## Charlotte Department of Transportation Memorandum

**Subject:** Rezoning Petition 12-096: Approximately 2.18 acres located on

## David Cox Rd Typical

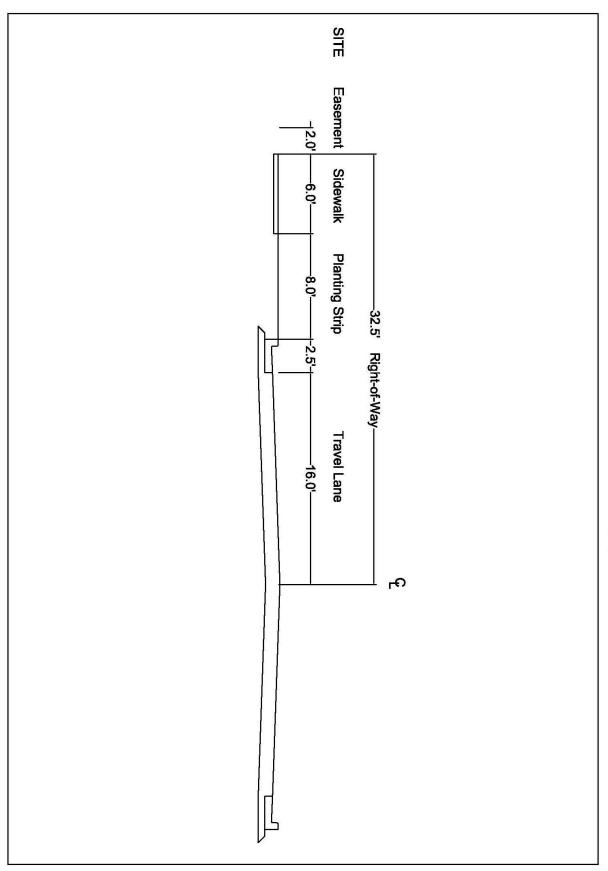
1. We request right-of-way be dedicated along David Cox Road 1 foot behind the back of the proposed sidewalk. The plan needs to show and label the existing and proposed right of way for David Cox Road.
